Service Bulletin

Revised Information: Adapted Prerequisites

Recommendation to replace integrated PC of DX-D 100 / DX-D 100 Wireless

Figure 1

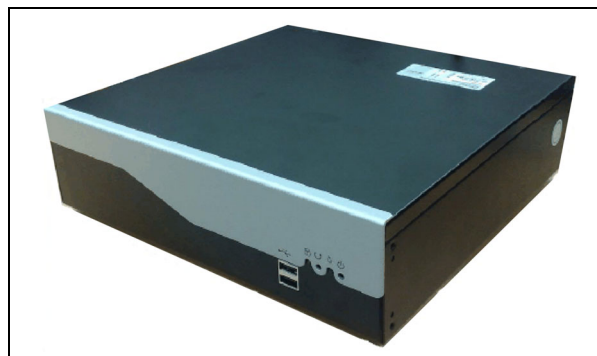
Symptom DX-D 100 / DX-D 100 wireless stopped working and smoke came out of the unit. Complete unit shuts down.

Cause Defective motherboard of the integrated PC.

New integrated PC

Solution Replace the integrated PC with the newer, revised version. Refer to section 2 and 3 for order numbers and instructions. Refer to the appendix of this document for the affected units, at which it is highly recommended to replace the PC.

Overview of the technical data of the new PC:
